Access Compliance Report

Public Rights-of-Way

(Curb Ramps)

Intersection ID: 12220	Main Street: E_6TH_ST	Cross Street: N_COLLEGE_ST	Location: W
ADA ID: 84F61ABAA9F8	Ramp Type: BlendTrans1	Initial Pass/Fail: Pass	Overall Compliance: No
Severity Score: 5.25			
Codes/Mitigation Info/Possible Solution		Field Measurements/Component Compliance

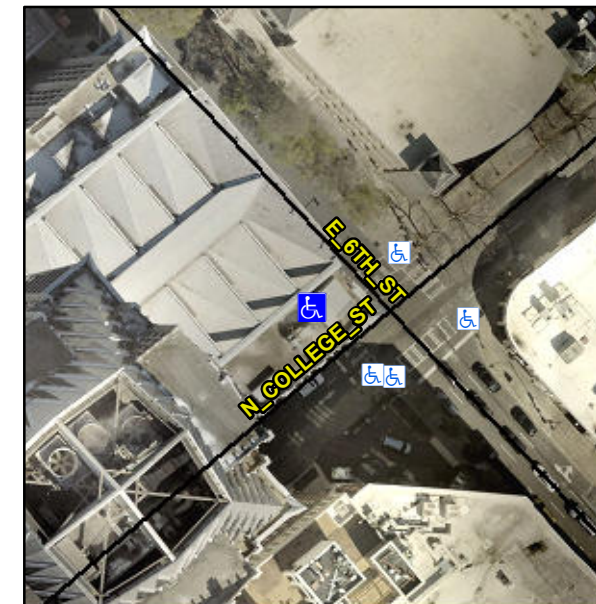
Not Found, R304.5.3, R304.2.2-Perp, R304.3.2-Para, R305.2, R304.5.4

Compliance	Description	Data	Compliance	Description	Data
N/A	Ramp Length (in)	36.0	Yes	BlendTrans Slope (%)	3.5
Yes	Ramp Width (in)	48.0	No	BlendTrans XSlope (%)	4.8
N/A	Flare Type LT	Sloped	N/A	Flare Type RT	Sloped
N/A	Flare Slope LT (%)	3.7	N/A	Flare Slope RT (%)	10.8
N/A	Flare Traversable LT?	No	N/A	Flare Traversable RT?	No
Yes	Landing Length (in)	48.0	Yes	DWS Provided?	Yes
Yes	Landing Width (in)	48.0	Yes	DWS Contrast?	Yes
No	Landing Slope (%)	3.1	Yes	DWS Length (in)	24.0
No	Landing X Slope (%)	4.2	Yes	DWS Full Width?	Yes
N/A	Landing Curb? (Y/N)	No	No	DWS Offset (in)	4.0
N/A	Shared Landing?	No			
Yes	Gutter Ponding?	No	No	Gutter Slope (%)	6.5
Yes	Gutter Lip Ht (in)	0.0	Yes	Gutter X Slope (%)	2.0
N/A	Painted X Walk1?	Yes	N/A	Painted X Walk2?	Yes
	X Walk 1 Direction	To SE		X Walk 2 Direction	To NE
	X Walk 1 Width (in)	100.0		X Walk 2 Width (in)	112.0
	X Walk 1 Slope (%)	2.6		X Walk 2 Slope (%)	3.4
	X Walk 1 X Slope (%)	1.7		X Walk 2 X Slope (%)	2.3

Yes	Ramp inside XWalk1?	Yes	Yes	Ramp inside XWalk2?	Yes
	Road Slope (%)	2.8		Clear Space?	Yes
	Road X Slope (%)	1.5	Yes	Clear Space to XWalk (in)	48.0
Yes	Any Obstructions?	No	Yes	Storm Grate/Utility Hazard?	No
	Obstruction Type			Storm Grate/Utility Type	
		N/A			N/A
			Yes	Surface Condition? (G/P)	Good
			No	Curb Slope (%)	24.1

Remove & Replace Curb Ramp With Two New Directional Ramps or Equivalent. Remove & Replace Gutter.
